PRATT & WHITNEY CANADA
SERVICE BULLETIN

P&WC S.B. No. 41119R5

TURBOSHAFT ENGINE
IGNITION EXCITER - REPLACEMENT OF

PT6C-67C

Ignition Exciter - Part Progression
Figure 1

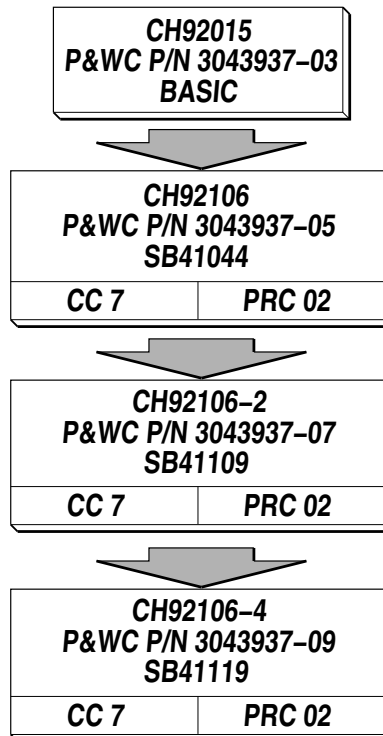
The ignition exciter spider switch is no longer available.

The ignition exciter spider switch has been obsoleted.

Replace the ignition exciter with one that has an available spider switch.

Replace the ignition exciter with a new one.

<u>New P/N</u>	<u>Keyword</u>	<u>Old P/N</u>	<u>Qty</u>	<u>Est. Unit List Price (\$US, 2023)</u>	<u>Instructions Dispositions</u>
	Ignition Exciter (0AFL4) P&WC P/N 3043937-07	CH92106-2	1		(A)(B)
CH92106-4	Ignition Exciter (0AFL4) P&WC P/N 3043937-09		1	15794.00	(A)
